Monthly Specification Update

Intel® Workstation Board S5520SC

Intel Order Number E68106-023

September, 2011

28. Wrong Fan Fault LED may glow if "other chassis" is selected when flashing FRUSDR21

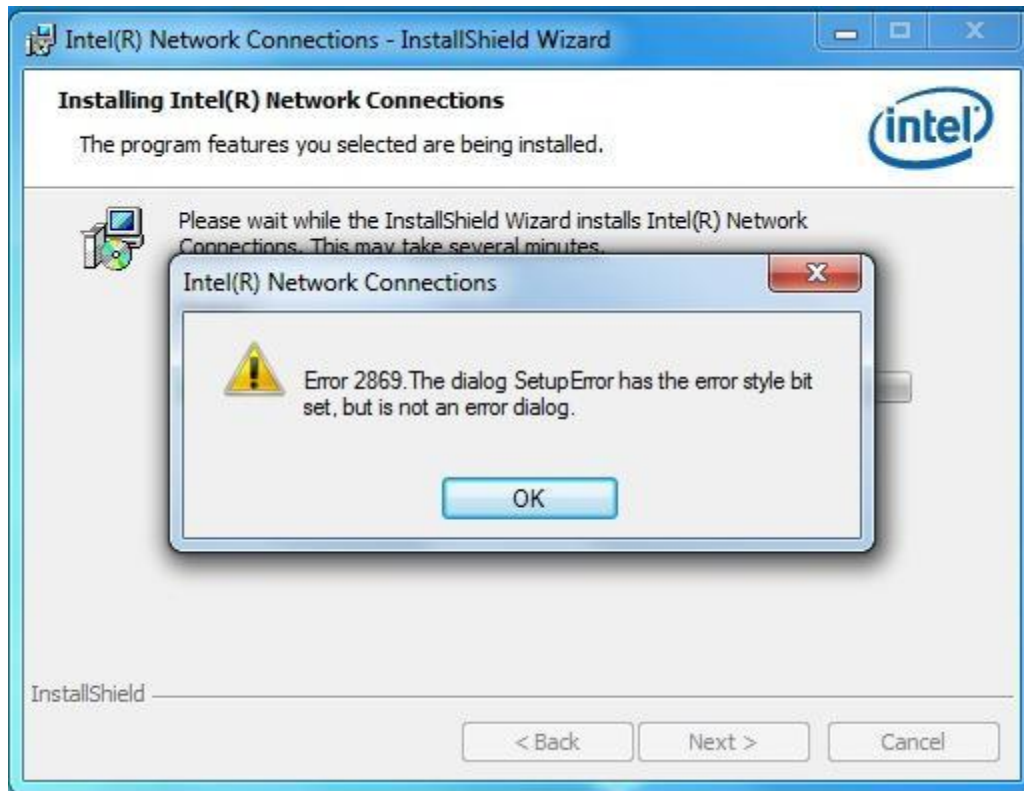
Problem When users update FRUSDR21 and select "other chassis" in the update process, users may see CPU FAN2 Fault LED glow when the upgrade process finishes. This issue occurs only when one CPU is installed in the motherboard.

Implication The unexpected CPU FAN2 Fault LED glowing event is due to a FRUSDR issue, however, there will be no functional impact to the system.

Status This issue is fixed by FRUSDR25.

30. NIC driver 15.1.1 may not be installed properly in Microsoft Windows Vista* or Microsoft Windows 7*

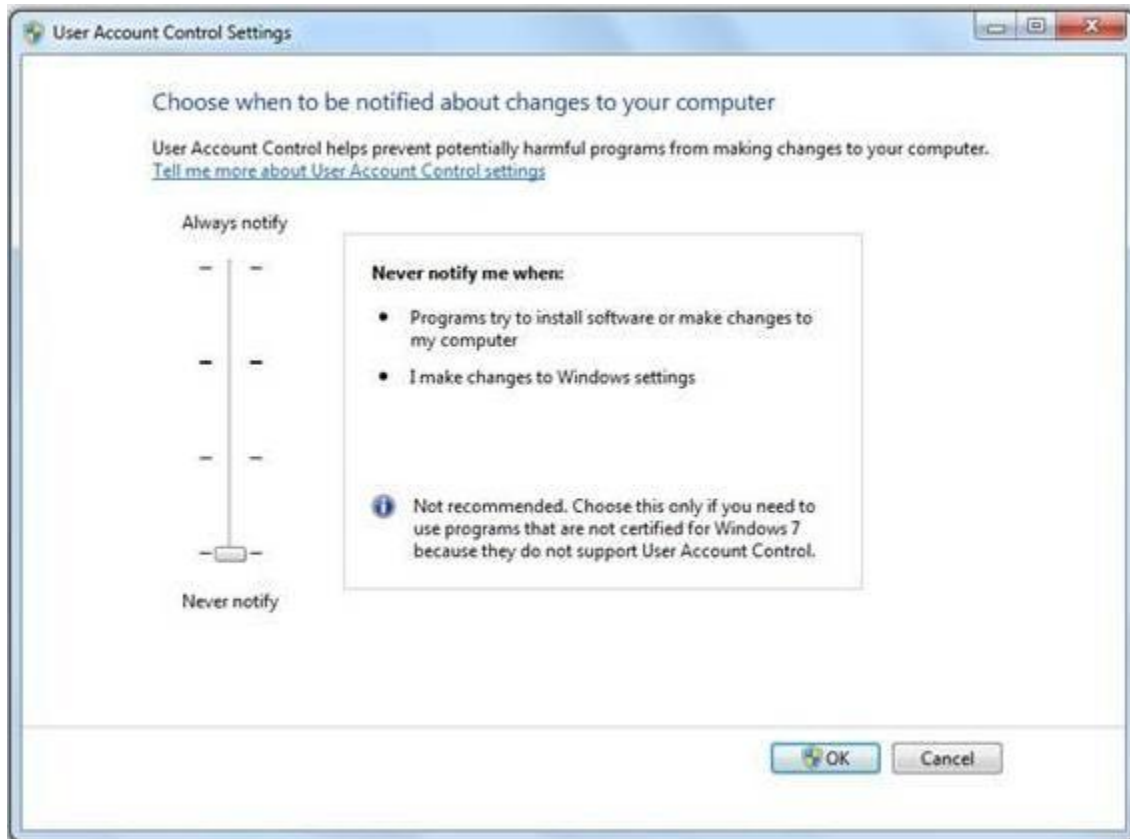
Problem	Users may find onboard NIC (Network Interface Card) driver version 15.1.1 may not get installed properly in Microsoft Windows Vista* or Microsoft Windows 7* when UAC (User Access Control) is set as "Default". Problem may occur during the installation process of the NIC driver, scramble display and unexpected message may display as following:
---------	---

- Implication** This is a permissions issue with Microsoft Windows Vista* and later operating systems. Permissions don't get elevated installing with PROSETDX.MSI, which is the file the batch file in the root directory points to. DXsetup gets the permissions elevated on Microsoft Windows Vista* and later operating systems, but they don't get elevated if you launch the MSI without DXsetup.
- Status** This issue will be fixed by future NIC driver release.
- Workaround** The following workaround can be used to navigate around the issue.
1. Users can browse to the \apps\prosetdx\ - 2. Users can also refer to below picture to set Windows UAC (User Account Control) to "Never notify", re-install the driver after a system reboot.
